Inspection Photos

11/24/2020

Operator: CAERUS PICEANCE LLC - 10456

Location ID: 312672

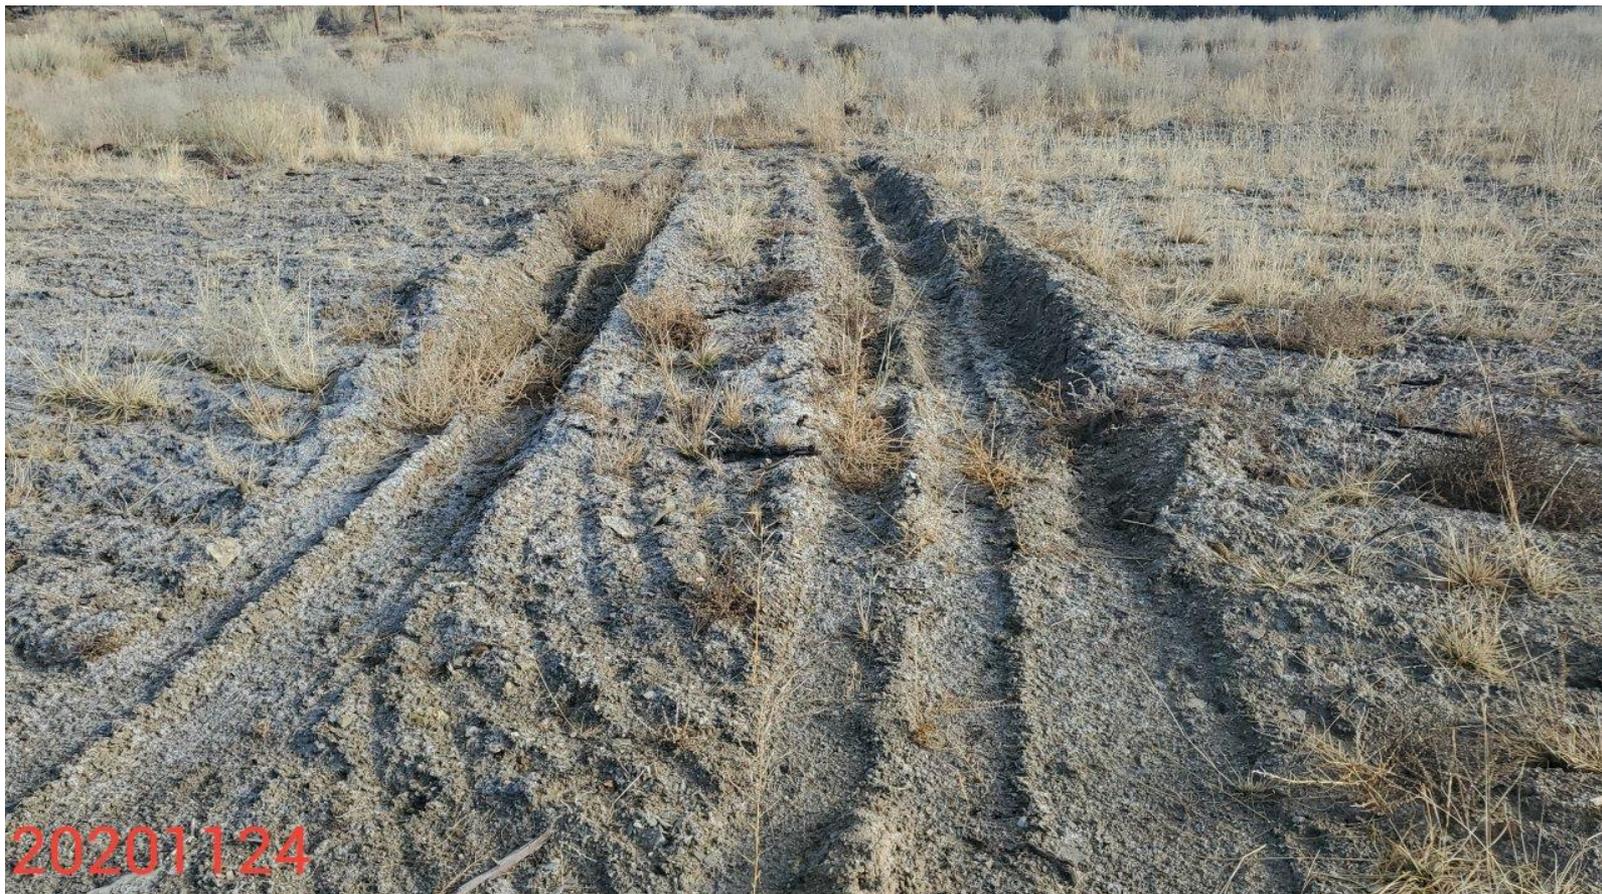
Photo 10: Photo taken from the Location, facing east. Photo shows vehicle travel on the location has resulted in deep ruts throughout the reclamation area; Additional reclamation work will be required in these areas to repair rutting, address potential compaction and revegetation concerns resulting from vehicle use.

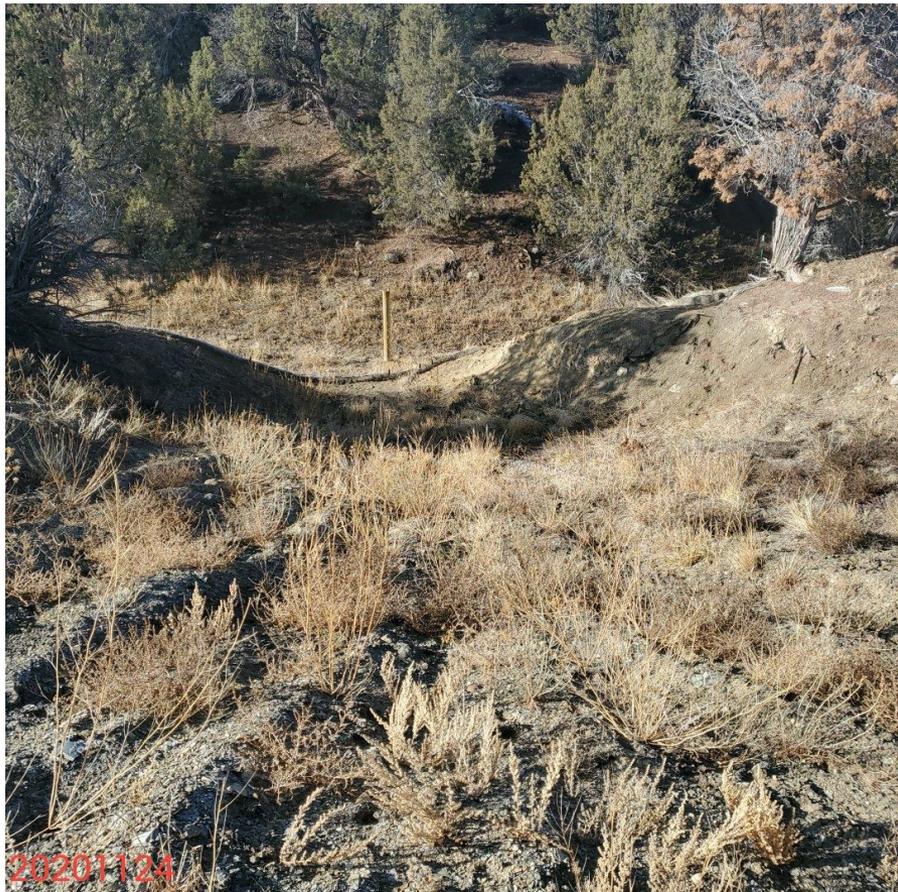
Photo 16: Continued from photo 15. Photo shows Access road at location entrance was constructed in a manner that dammed a drainage on the west end of the Location; BMPs missing or insufficient to allow water movement within the drainage. Access road requires graveling. Photo also example of BMPs missing, or insufficient to stabilize slopes of the Location.
